**TOWN OF MOUNTAIN VILLAGE
REGULAR DESIGN REVIEW BOARD MEETING
AGENDA**

THURSDAY DECEMBER 3, 2020 10:00 AM

4.	10:10	60	Ward Applicant	Quasi-Judicial	Consideration of a Design Review: Initial Architecture Review for a new single-family residence on Lots 517 & 518 (518R) 146 Russell Drive, pursuant to CDC Section 17.4.11

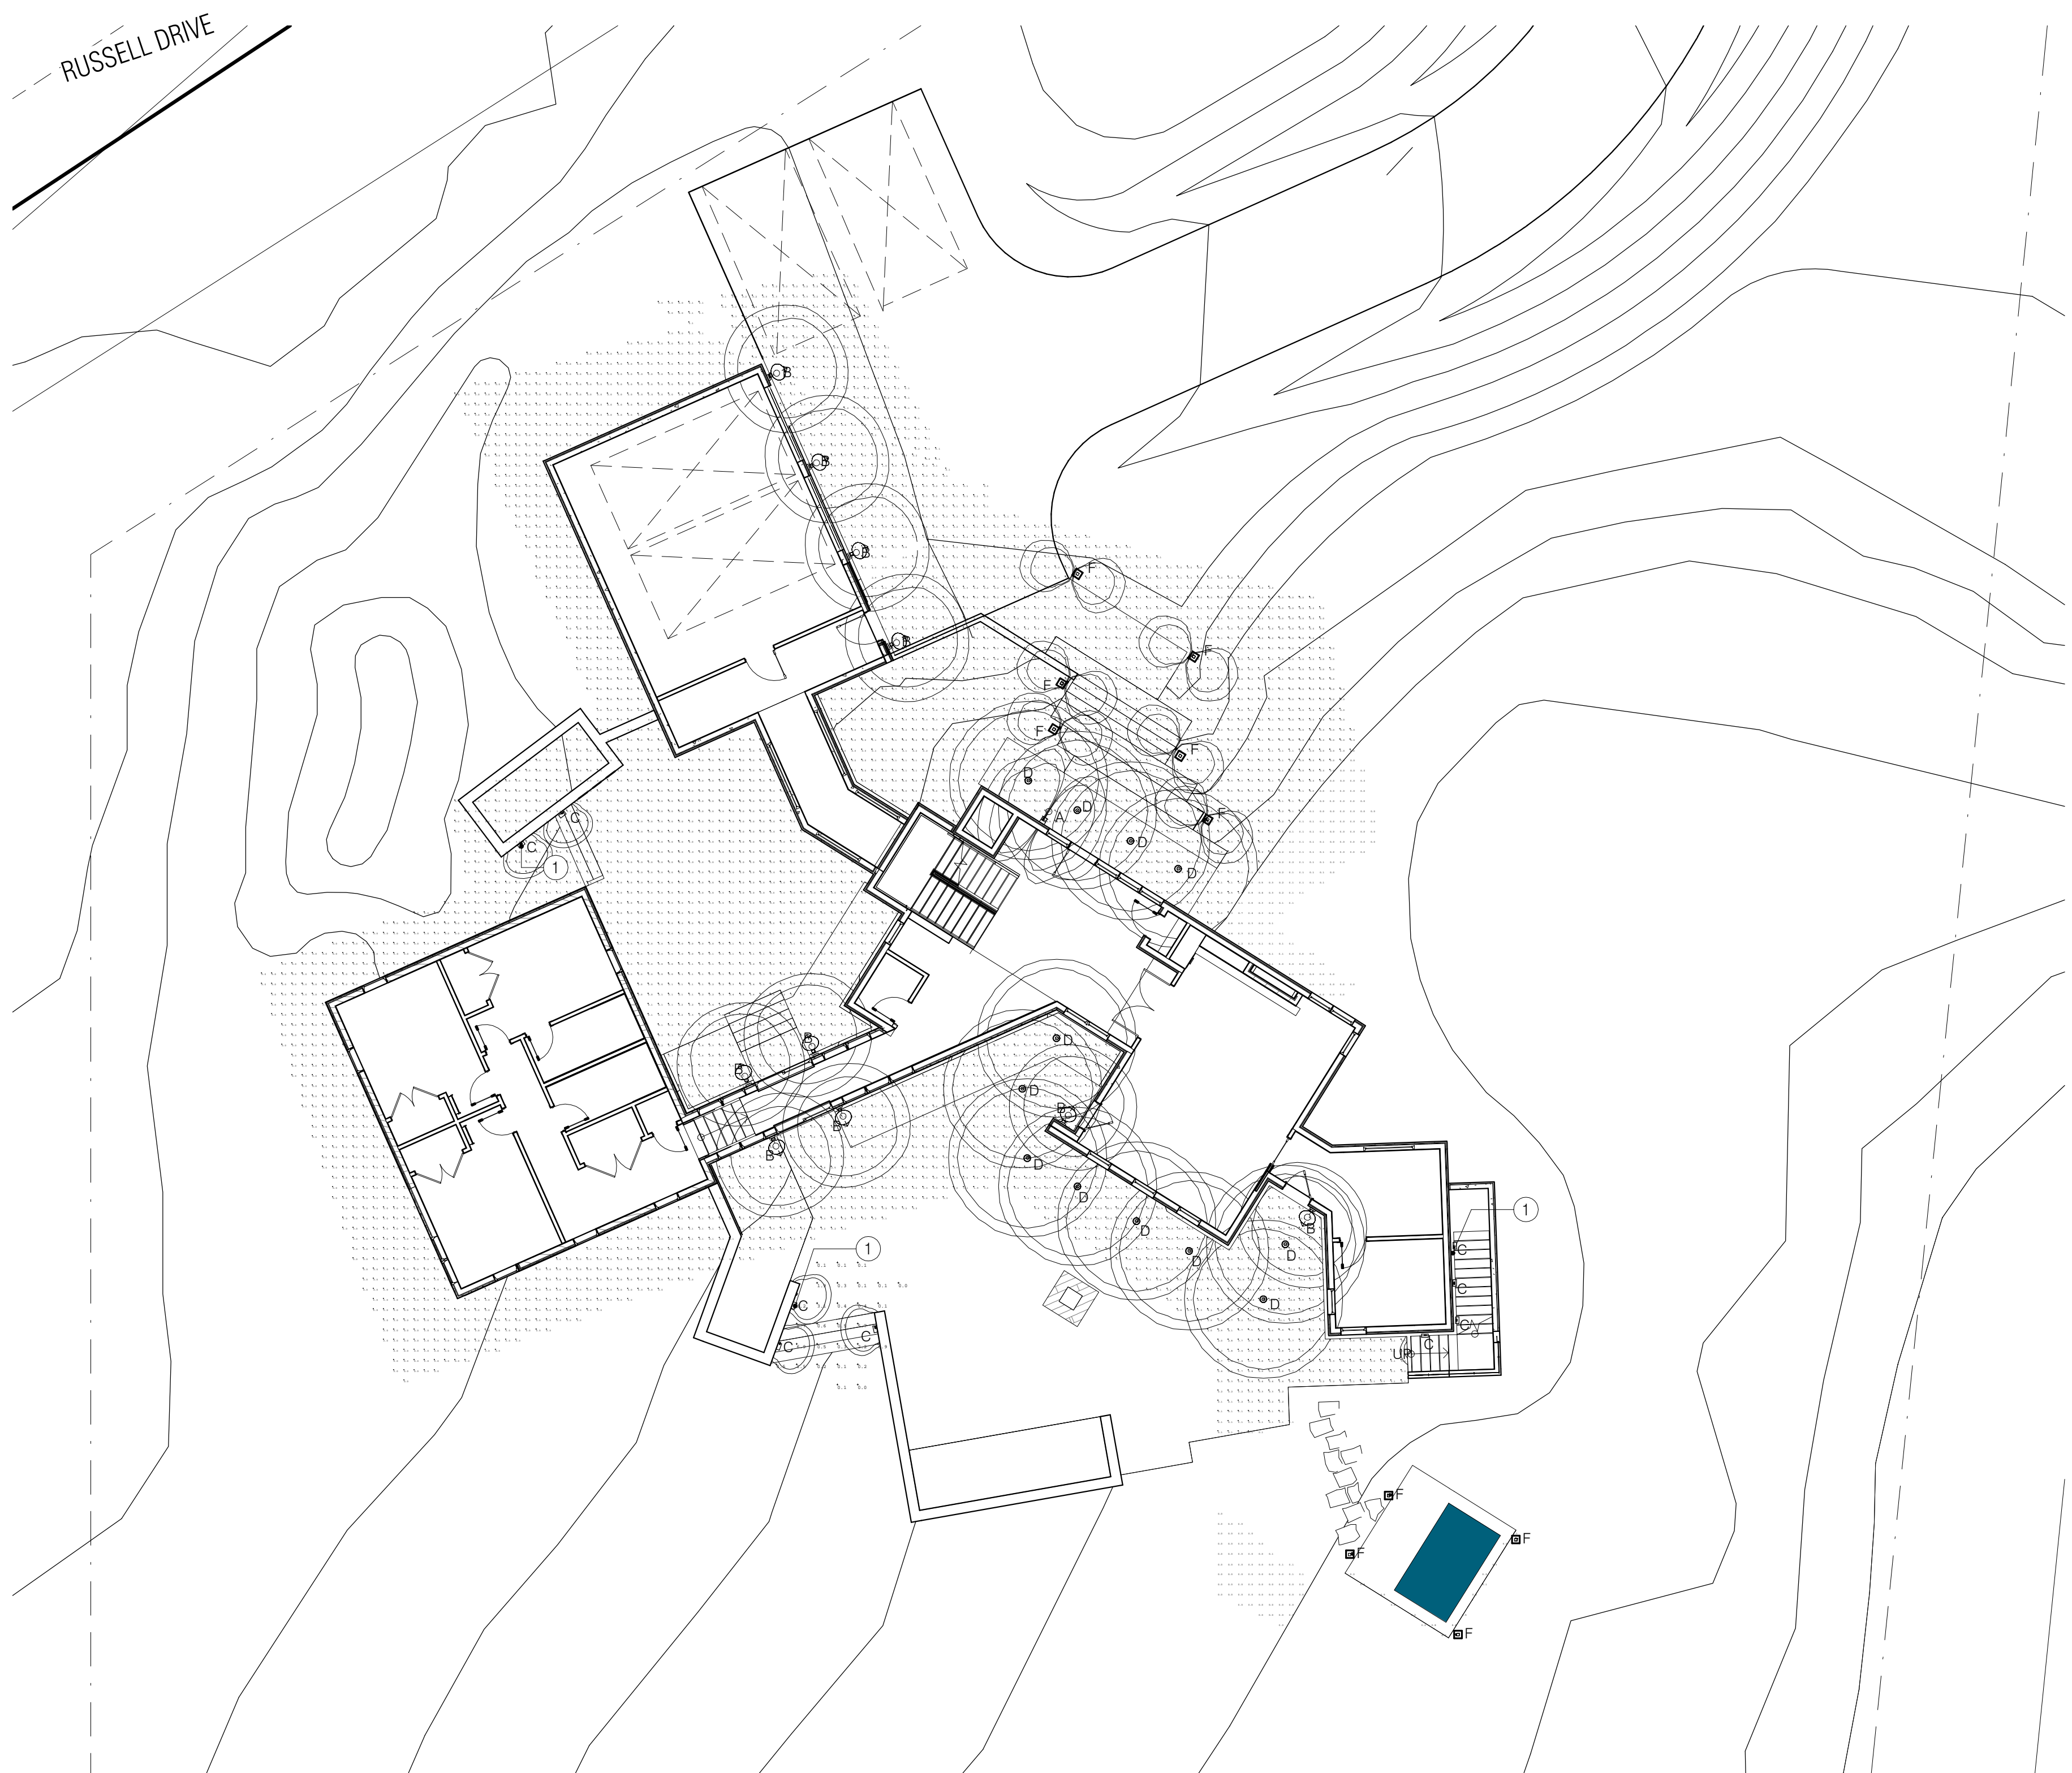
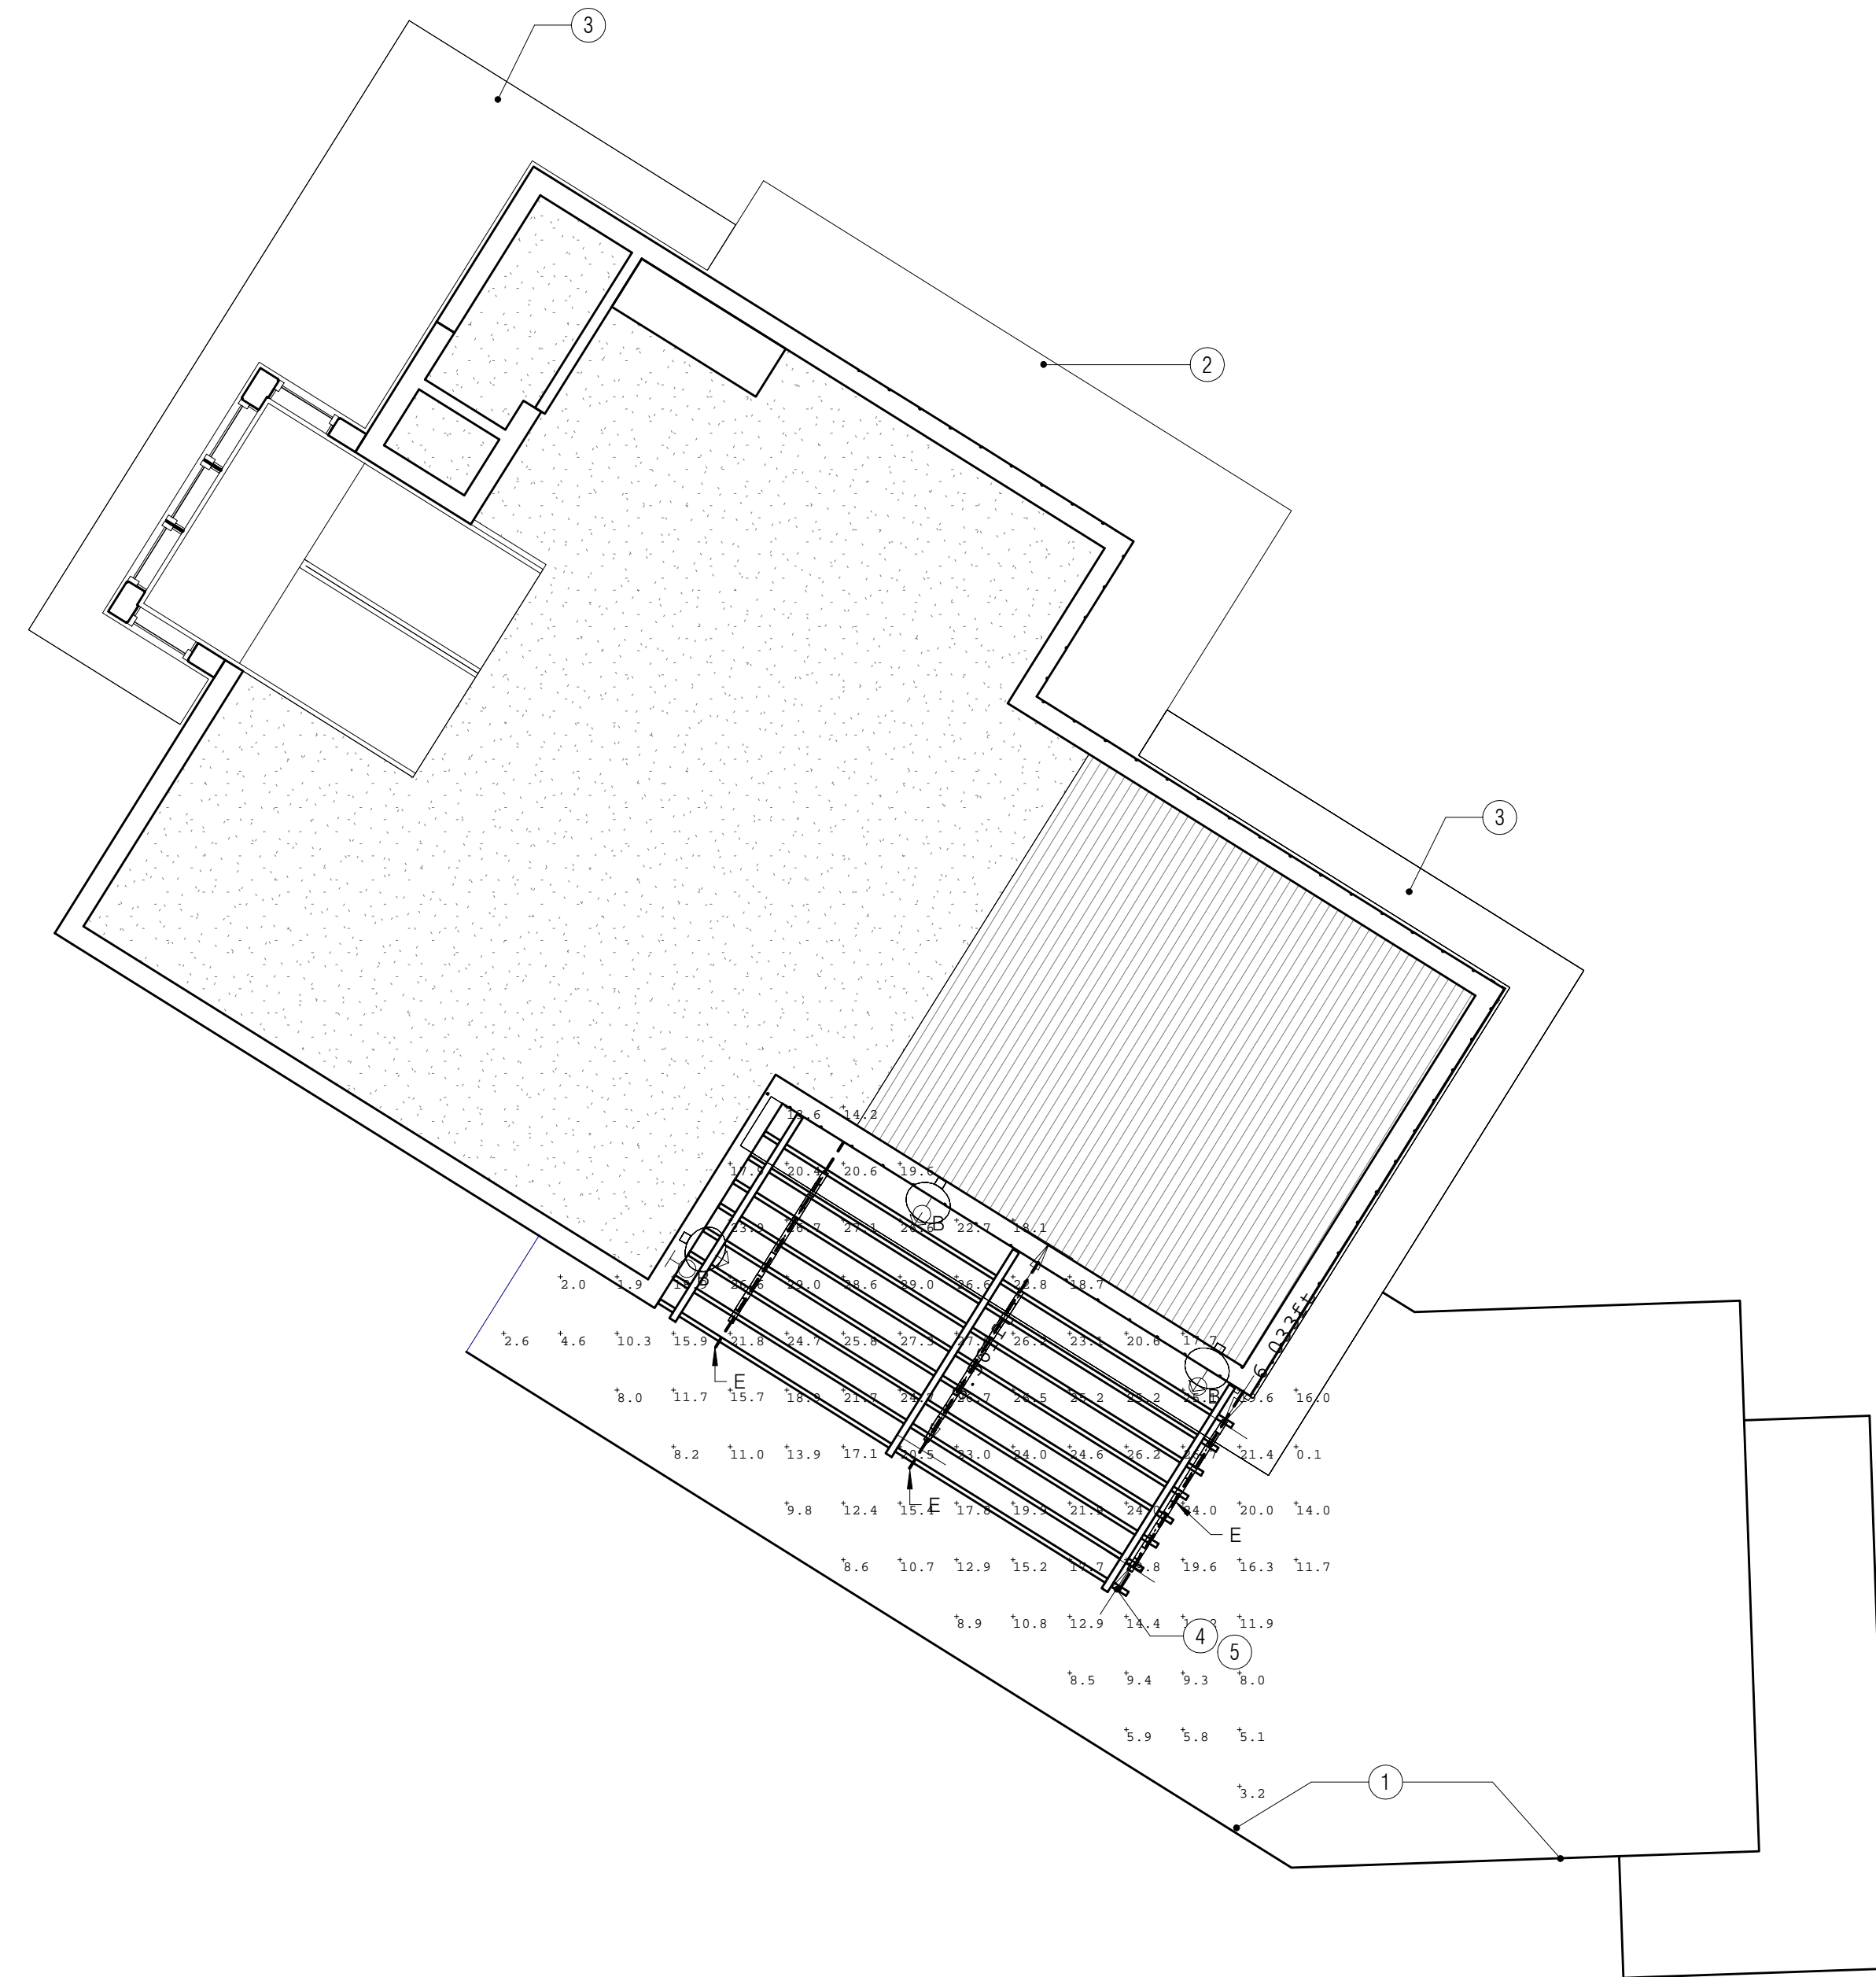
Staff: The applicant has provided a preliminary lighting plan demonstrating the locations, heights and types of fixtures. They have also included individual cut sheets for each fixture documenting lumens and CCT, and have provided a full foot-candle study of the exterior of the home to demonstrate that no light trespass is occurring. The foot candle study is incorrect on the third floor deck, as they have since replaced a fixture that didn't meet CDC requirements. They will submit a corrected version for final. It should be noted that the Lighting Plan is not required at IASR.

- 2) Prior to the submittal for a Final Architectural Review, the applicant shall provide an updated lighting plan to include specific fixture cut sheets, dimmer switch details, and a photometric study of the Lot demonstrating compliance with the CDC lighting standards.
